REGIONAL REVIEW NOTIFICATION

Name of Proposal: Fairburn Storage
Review Type: Development of Regional Impact

Preliminary Report:	June 16, 2008	**DEVELOPMENT OF REGIONAL IMPACT REVIEW REPORT**	Project:	Fairburn Storage #1875
Final Report Due:	July 16, 2008		Comments Due By:	June 30, 2008

REVISED PROPOSED DEVELOPMENT:

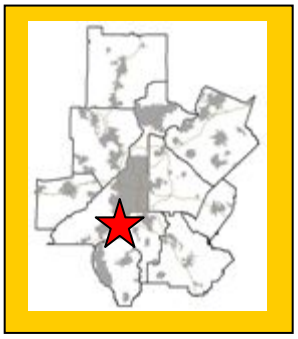
Although no plans were submitted at scale, the site appears to be about 80 percent impervious. Water quality control ponds are also shown on the site plan. The project needs to conform to all County water supply watershed requirements, including impervious surface and water quality best management practices requirements.
